Technical Service Bulletin

Subject: AIR CONDITIONER DOES NOT BLOW COLD AIR DUE TO CRACKED COOLER PIPE (HI) A (REFRIGERANT LEAK)	Bulletin No.: 07-002/21
	Last Issued : 10/08/2021

Location of cracking

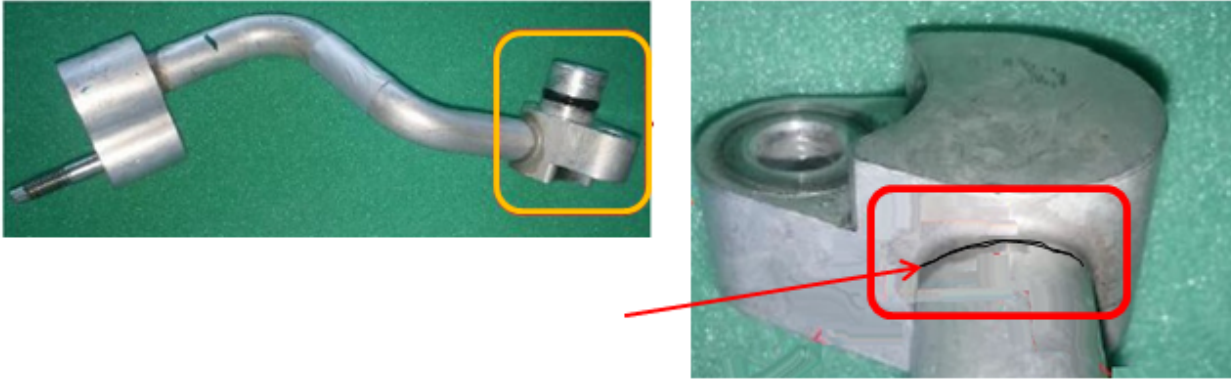
Some vehicles may experience that the A/C does not blow cold air (blows warm air) due to a refrigerant leak. This is caused by a crack in the cooler pipe (HI) A (1) due to engine vibration. To correct this issue, the material and thickness of the cooler pipe (HI) A has been changed to increase durability (pipe diameter has been changed from 12mm to 16mm).

1. Verify customer concern.
2. Inspect the cooler pipe (HI) A.
 - If the cooler pipe (HI) A is cracked, replace the cooler pipe (HI) A with a modified one according to the instructions on MGSS (REFRIGERANT LINE REMOVAL/INSTALLATION).
 - If the cooler pipe (HI) A is not cracked, this TSB is not applicable. Refer to troubleshooting procedure on MGSS (NO COOL AIR [CLIMATE CONTROL SYSTEM]).
3. Verify repair.
